Date: August 17, 2022

Re: 74-80 Maynard Road, Sudbury, MA (Assessors map G08 Parcels 0025 and 0500),  
DEP #301-1341

LIMIT OF DISTURBANCE CHANGE  
 -BONNIE BROOK ESTATES-  
 DEFINITIVE PLAN OF LAND  
 MAYNARD ROAD  
 SUDBURY, MA

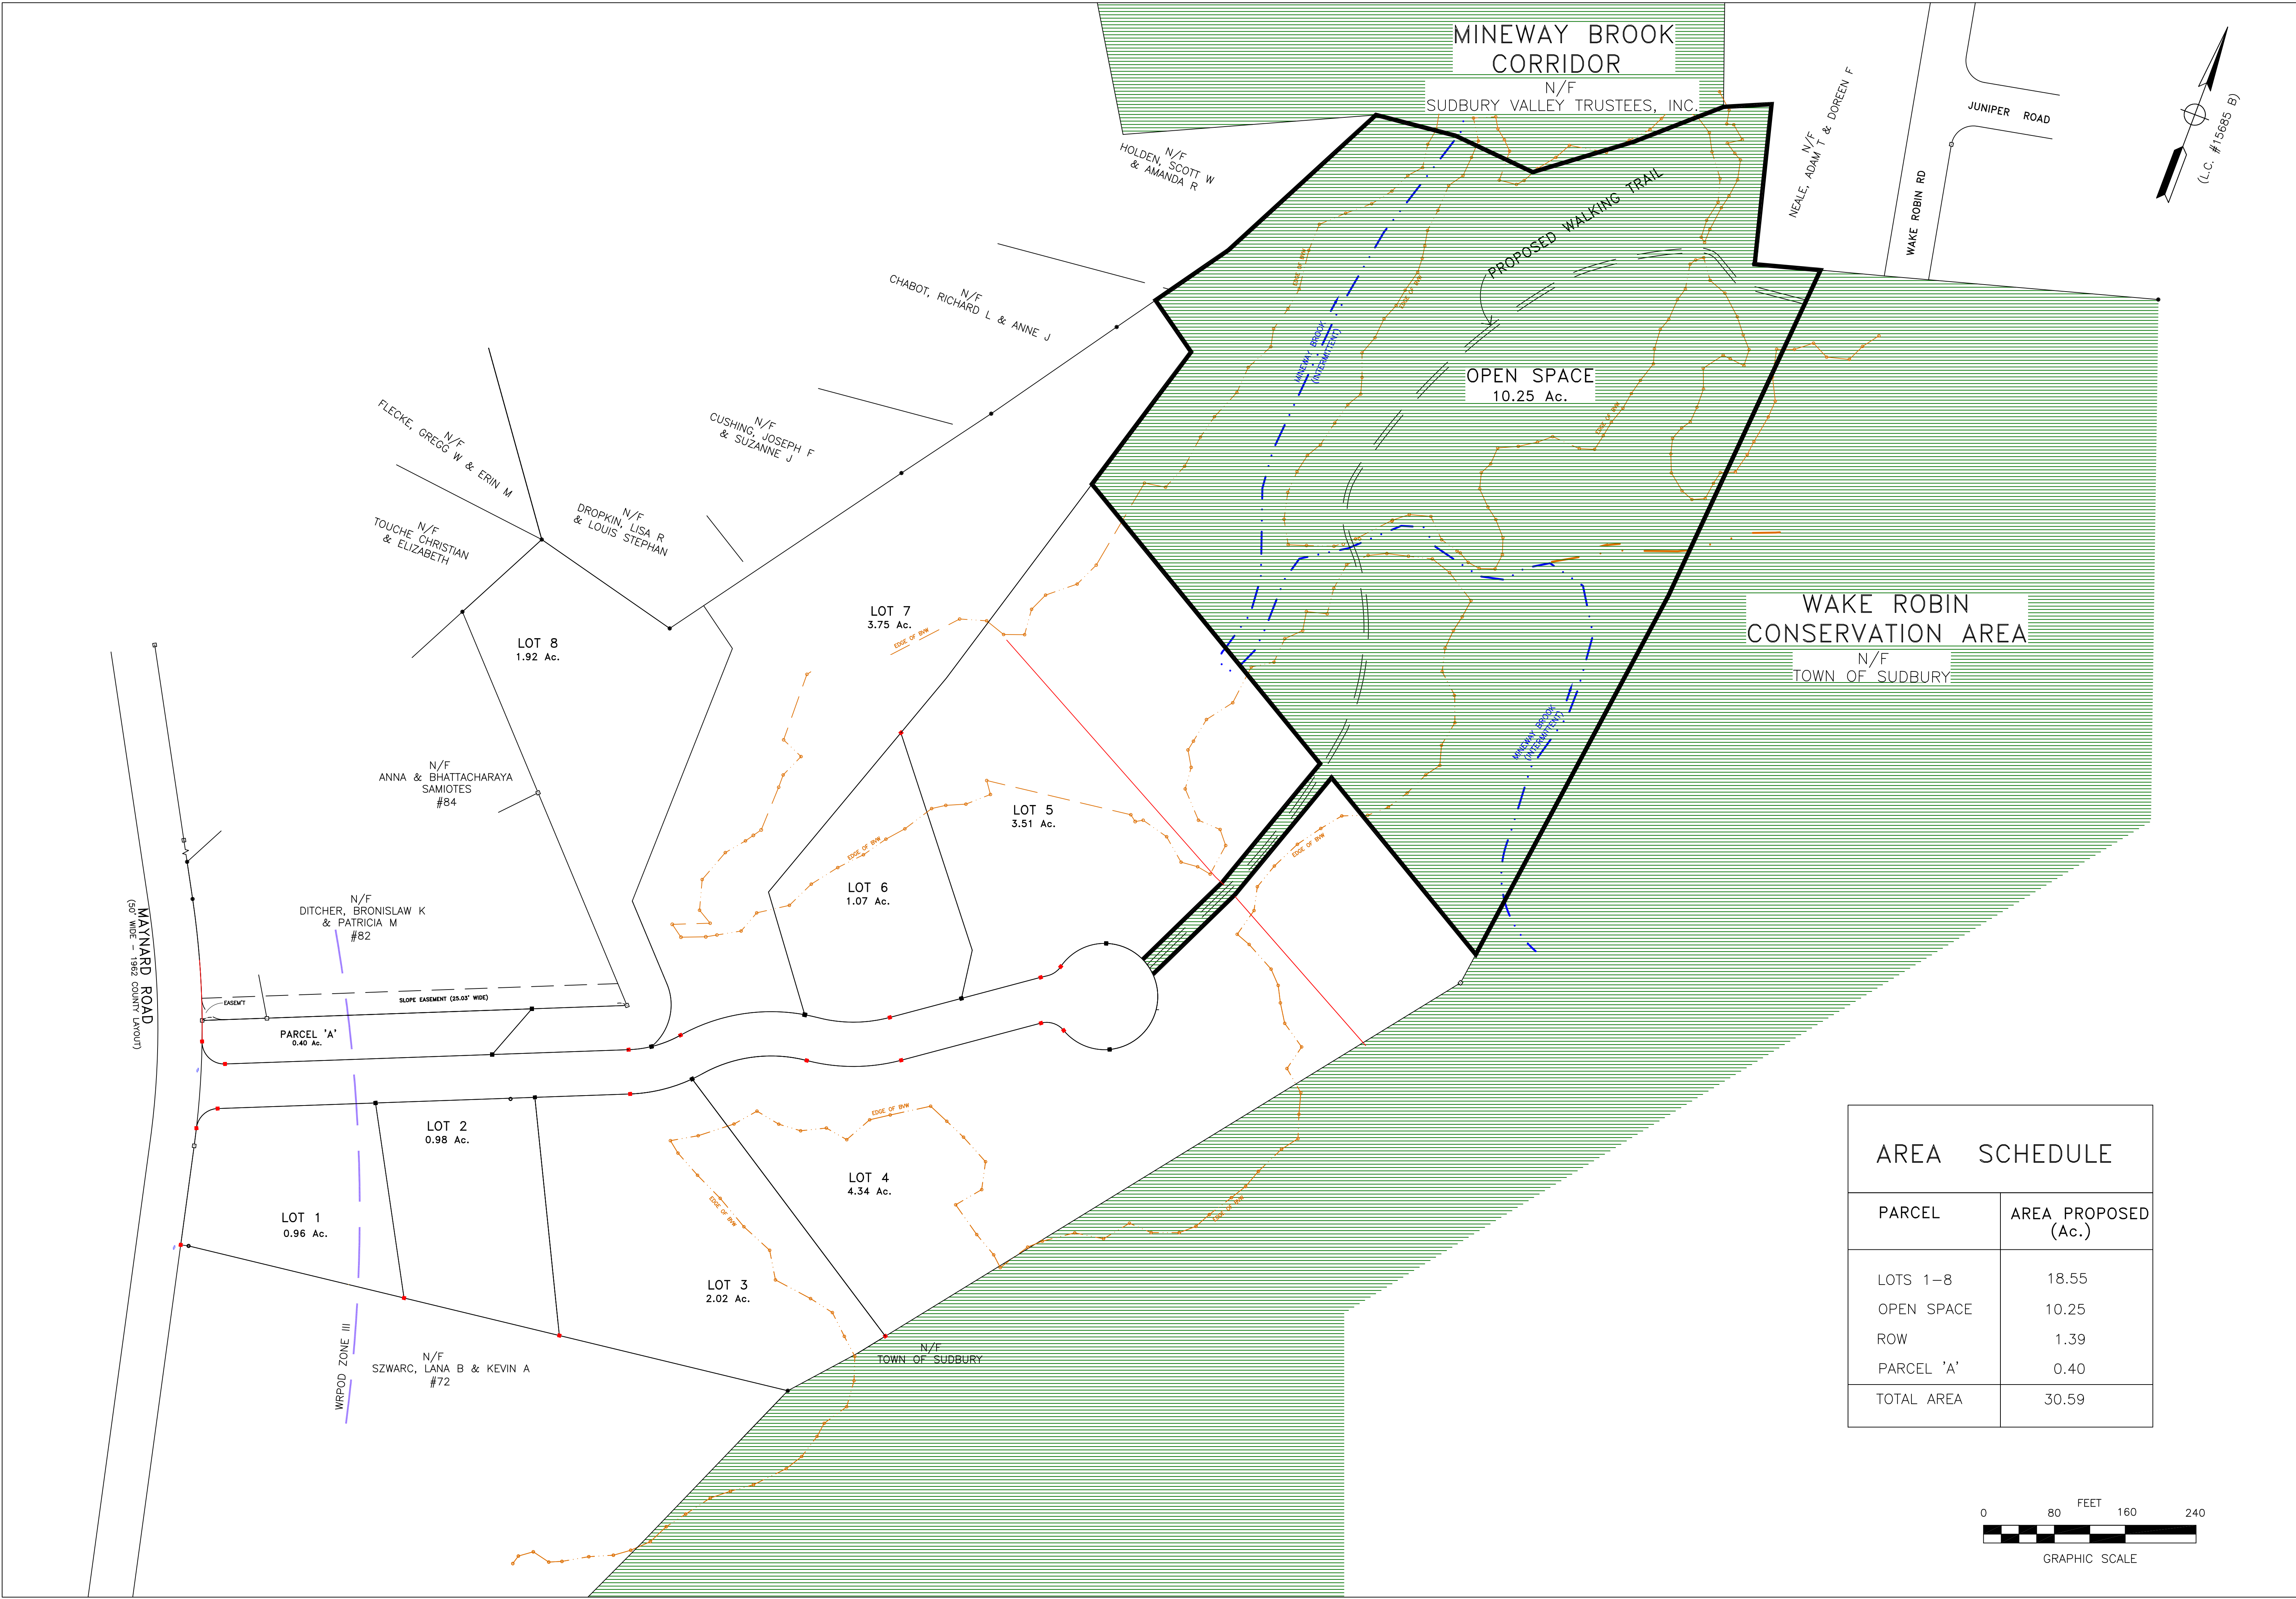
1. The new 8-lot plan eliminated one currently unbuildable lot on the middle peninsula and make the two middle peninsulas into the mitigation open space that will significantly improve the connectivity for the existing conservation land and much better access for potential trails.

2. The current revised plan will provide upland access from the new roadway to the open space.
3. We squared out some backyard of the 6 house lots so the future home owners have a better usable yard and not to endanger the house with large trees.

4. Compared with the previous plan, there will be a total 19422 sf of AURA disturbed and 44559 SF mitigation area provided for the disturbance (2.29 to 1 mitigation ratio). This change is for the reason that we believe that if people are provided with squared out reasonable size backyard area, it will be better off in the long run to enforce the no-disturbance line. We can work out the details of the demarcation, mainly behind the lots. Combination of boulders and Fino markers can do the job plus a perpetual Conditions in the OOC. We will work out an O/M plan when number of lots and limit of work are agreed with PLB.

5. We also identified some additional mitigation area on the plan after taking to Ms. Capone. We marked three additional mitigation areas (A, B, C), which can boost the

mitigation area to 75514 SF (3.89 to 1 ratio for the additional disturbance) and boost the overall mitigation ration to 3.31 to 1, better than the previously agreed 9-lot plan. We can finalize this when PLB approved the lot number.

Potential mitigation area A = 8702 SF  
 B = 17994 SF  
 C = 4259 SF  
 Subtotal = 30955 SF  
 Mitigation ratio: 3.31 > 3.13 for original mitigation plan

LIMIT OF DISTURBANCE CHANGE*	
LOT	L.O.D. CHANGE (S.F.)
#3	1,911 SF
#4	7,463 SF
#5	2,666 SF
#6	4,537 SF
#7	1,695 SF
#8	1,150 SF
TOTAL=19,422 SF

Mitigation area for the added yard grading: 44559 SF (2.29 to 1 ratio)  
 Potentially increased to 75514 SF (3.89 to 1 mitigation ratio)  
 \* - PROPOSED LIMIT OF DISTURBANCE ON PREVIOUS PLAN=63,985 SF
